6. Stewart Subdivision 2023 Addition; KPB File 2023-031R1

Stewart Subdivision 2023 Addition

Revised Preliminary Plat

STAFF REPORT

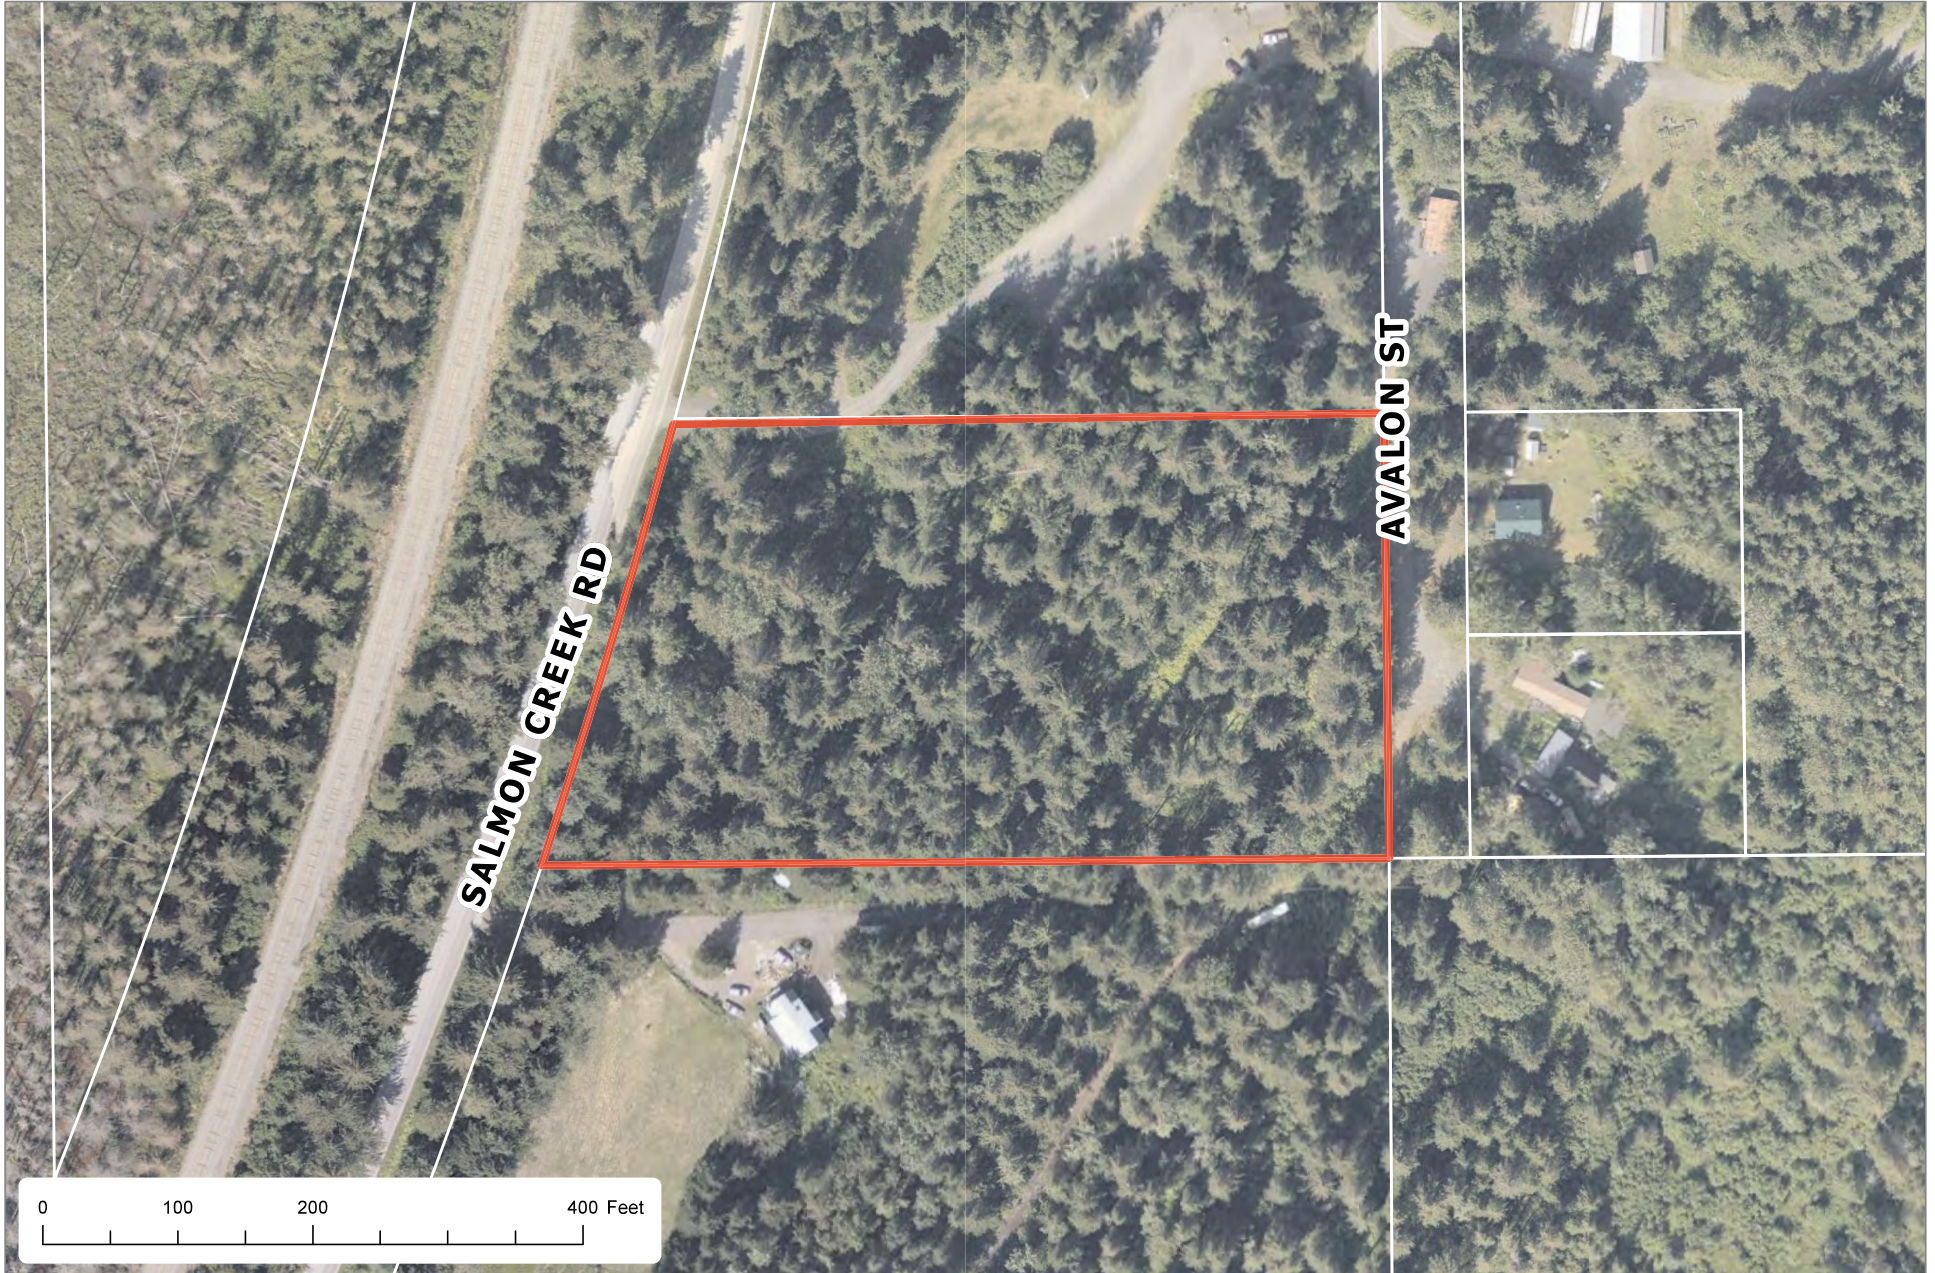
Add KPB File 2023-031R1 to the drawing.

- Staff recommendation:** Add Alaska to the location
- D. A vicinity map, drawn to scale showing location of proposed subdivision, north arrow if different from plat orientation, township and range, section lines, roads, political boundaries, and prominent natural and manmade features, such as shorelines or streams;

- Staff recommendation:** Provide a label for Alaska Railroad with width to the west. The labels for Lot 1 and Lot 2 of Avalon Subdivision need swapped.

- *"No access to state maintained rights-of-way permitted unless approved by the State of Alaska Department of Transportation."*
- *Provide a note for the easement located along Avalon Street with the information as this easement was specifically granted to the City of Seward and the new easement will be for any utility provider. "This property is subject to a 10 foot wide utility easement granted to the City of Seward by document 2016-000415-0. The easement is within the 10 foot utility easement being granted by this plat adjacent to Avalon Street."*

VICINITY 1" = 1 mile MAP

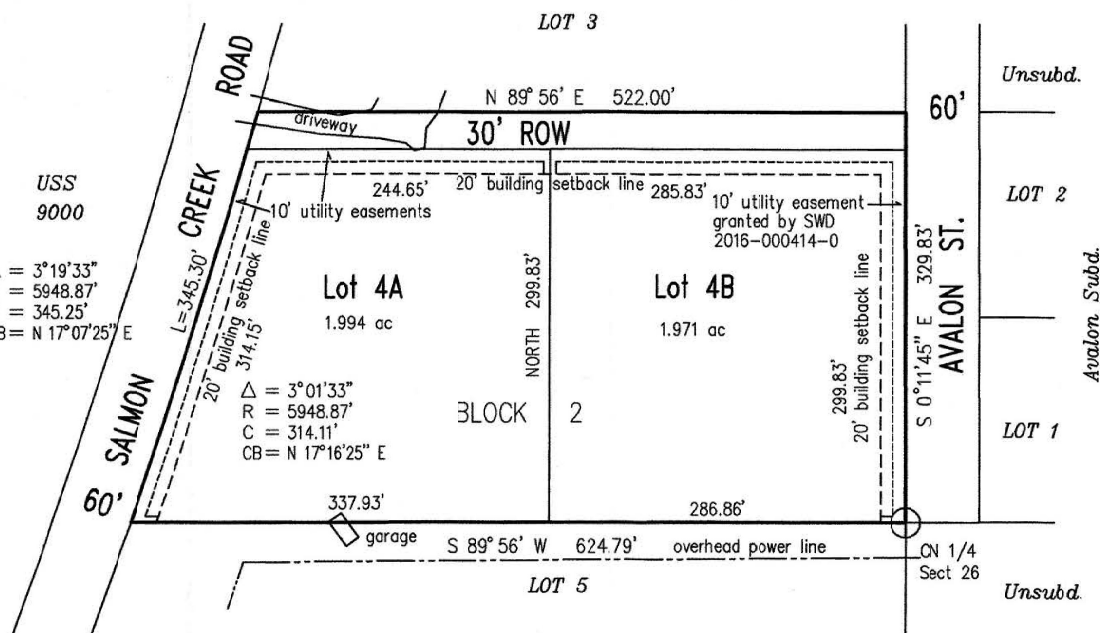
- Staff recommendation:** Clear up the overstrikes to make map easier to read.
Continue Salmon Creek Road north.
Adjust the map so the subdivision is in the NW1/4 as it is.
